**SUBDIVISION,
PLANNING APPROVAL, &
ZONING AMENDMENT STAFF REPORT****Date: October 21, 2021**

<u>NAME</u>	Les Robinson, LLC (James Hughes, Agent)
<u>SUBDIVISION NAME</u>	Anytime Storage Subdivision
<u>LOCATION</u>	1653 Spring Hill Avenue (South side of Spring Hill Avenue, 385'± East of Gilbert Street).
<u>CITY COUNCIL DISTRICT</u>	District 2
<u>PRESENT ZONING</u>	R-1, Single-Family Residential District and B-1, Buffer Business District
<u>PROPOSED ZONING</u>	B-2, Neighborhood Business District
<u>AREA OF PROPERTY</u>	1 Lots / 2.3± Acres
<u>CONTEMPLATED USE</u>	Subdivision approval to create one (1) legal lot of record from four (4) metes-and-bounds parcels; Planning Approval to allow a self-storage facility in a B-2, Neighborhood Business District; and Rezoning from R-1, Single-Family Residential District and B-1, Buffer Business District to B-2, Neighborhood Business District.
<u>TIME SCHEDULE FOR DEVELOPMENT</u>	Immediate
<u>ENGINEERING COMMENTS</u>

SITE PLAN

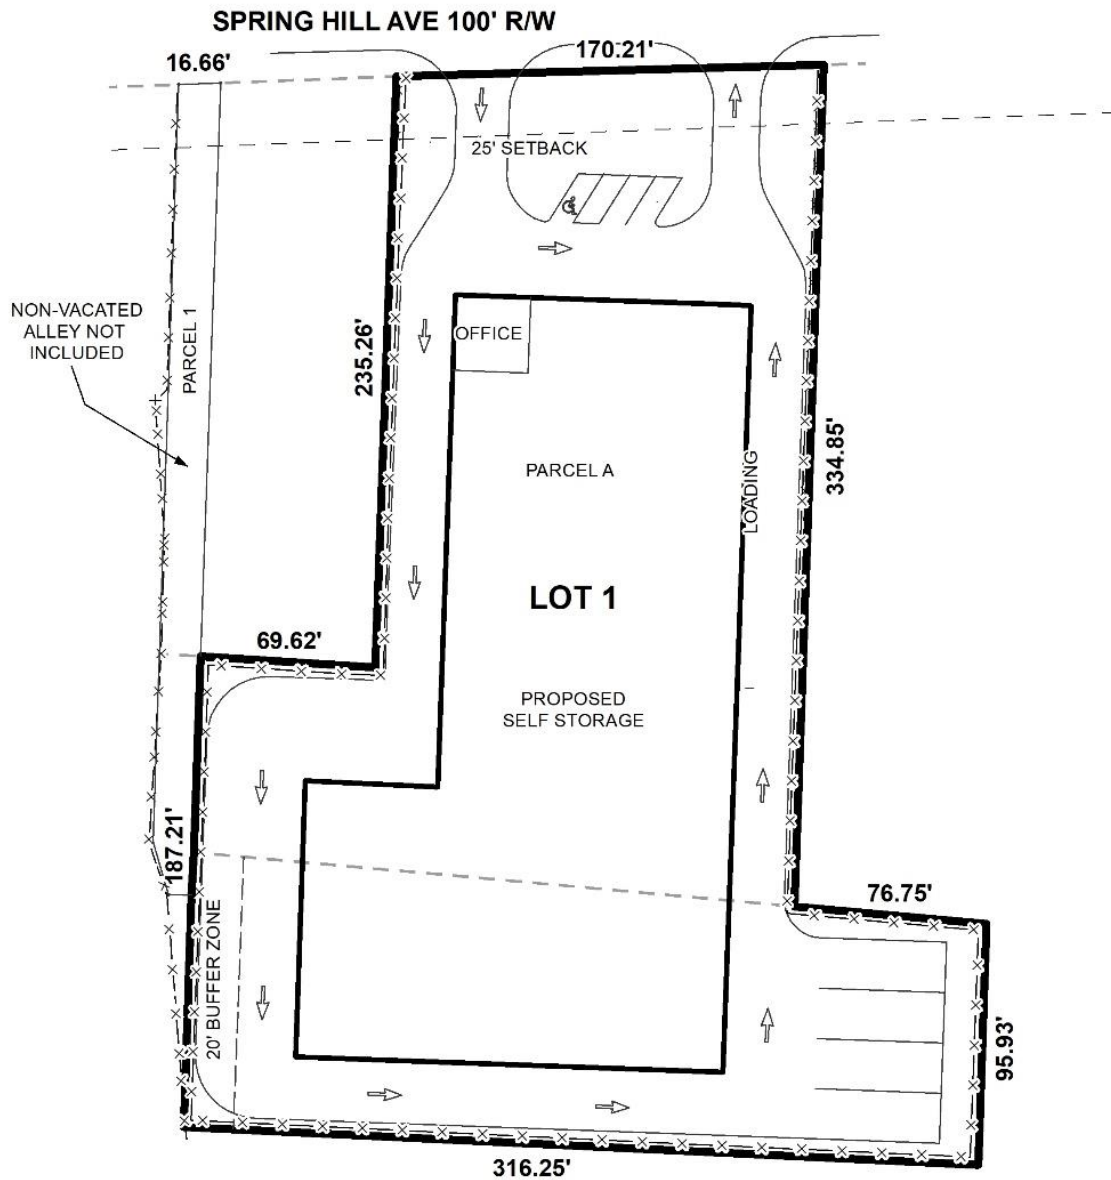
The site plan submitted depicts a single 41,605± square foot building on the site, to include a 900 square foot office. No mention is made of how tall the proposed structure will be. Three (3) parking spaces are required, and seven (7) are illustrated.

No dumpsters are illustrated on the site plan submitted, and there is no note stating that curbside pickup will be utilized. If approved, either a compliant dumpster should be shown, or a note stating curbside pickup will be utilized.

The site abuts R-1, Single-Family Residential zoning to the East, South, and West. As such, a compliant residential buffer will be required at the time of development, and should be depicted on the site plan, if approved.

A sidewalk is not depicted along Spring Hill Avenue, and will be required at the time of development. If approved, the site plan should be revised to illustrate the required sidewalk.

The site plan was revised to depict a six-foot high privacy fence around the perimeter of the property. It should be noted, that if approved, the fence will need to be reduced to three-feet tall within the front 25-foot setback.

The previous site plan submitted labeled the proposed structure as being 41,605 square feet. The current site plan shows the structure to be 40,710 square feet, for a reduction by 895 square feet. The proposed office square footage remains the same, therefore there is no change in the amount of parking required.

The subject site was rezoned from R-1, Single-Family Residential District to B-1, Buffer Business District in 1979, with a condition that “a 20’ natural buffer be provided along the West property line”, in response to concerns from Beverly Court residents. The site plan does have a “20’ buffer zone”, albeit not a natural buffer, shown over the Western portion of the site, presumably in reference to this. The property at 1657 Spring Hill Avenue was rezoned from R-1 to B-1 in 1994, making the provision of a buffer along that portion unnecessary. However, it may be appropriate for the site to be required to provide and maintain a 20’ buffer along the West property line where abutting residentially zoned properties. While doing so will have an impact on the proposed site plan, it appears they will still maintain compliance with regulations regarding traffic circulation.
